Access Compliance Report

Public Rights-of-Way

Intersection ID: 15762	Main Street: HOPEDALE_AV	Cross Street: QUEENS_RD	Location: NW
ADA ID: EB49E84285B6	Ramp Type: Perp	Initial Pass/Fail: Fail	Overall Compliance: No
		Severity Score: 25

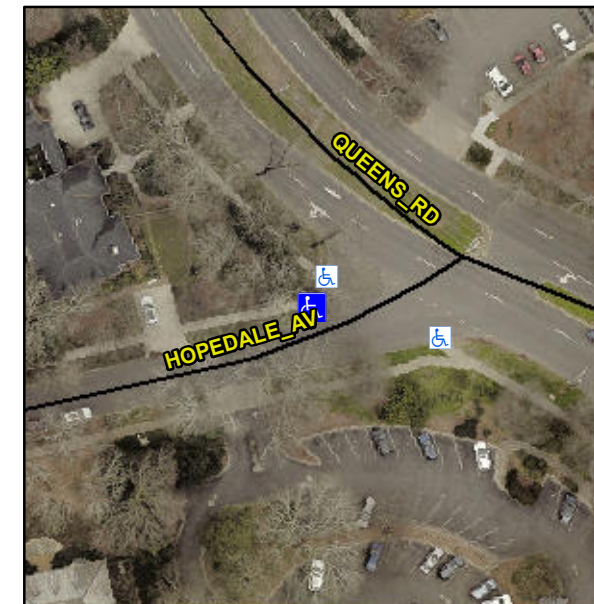
Not Found, R304.2.2, R304.5.3

Compliance	Description	Data	Compliance	Description	Data
N/A	Ramp Length (in)	36.0	No	Ramp Slope (%)	10.9
Yes	Ramp Width (in)	48.0	No	Ramp XSlope (%)	6.3
N/A	Flare Type LT	N/A	N/A	Flare Type RT	N/A
N/A	Flare Slope LT (%)	N/A	N/A	Flare Slope RT (%)	N/A
N/A	Flare Traversable LT?	N/A	N/A	Flare Traversable RT?	N/A
N/A	Landing Length (in)	N/A	N/A	DWS Provided?	N/A
N/A	Landing Width (in)	N/A	N/A	DWS Contrast?	N/A
N/A	Landing Slope (%)	N/A	N/A	DWS Length (in)	N/A
N/A	Landing X Slope (%)	N/A	N/A	DWS Full Width?	N/A
N/A	Landing Curb? (Y/N)	N/A	N/A	DWS Offset (in)	N/A
N/A	Shared Landing?	N/A			
N/A	Gutter Ponding?	N/A	N/A	Gutter Slope (%)	N/A
N/A	Gutter Lip Ht (in)	N/A	N/A	Gutter X Slope (%)	N/A
N/A	Painted X Walk1?	No	N/A	Painted X Walk2?	N/A
	X Walk 1 Direction	To SE		X Walk 2 Direction	N/A
N/A	X Walk 1 Width (in)	N/A	N/A	X Walk 2 Width (in)	N/A
	X Walk 1 Slope (%)	4.8		X Walk 2 Slope (%)	N/A
	X Walk 1 X Slope (%)	4.1		X Walk 2 X Slope (%)	N/A

Remove & Replace Entire Ramp.
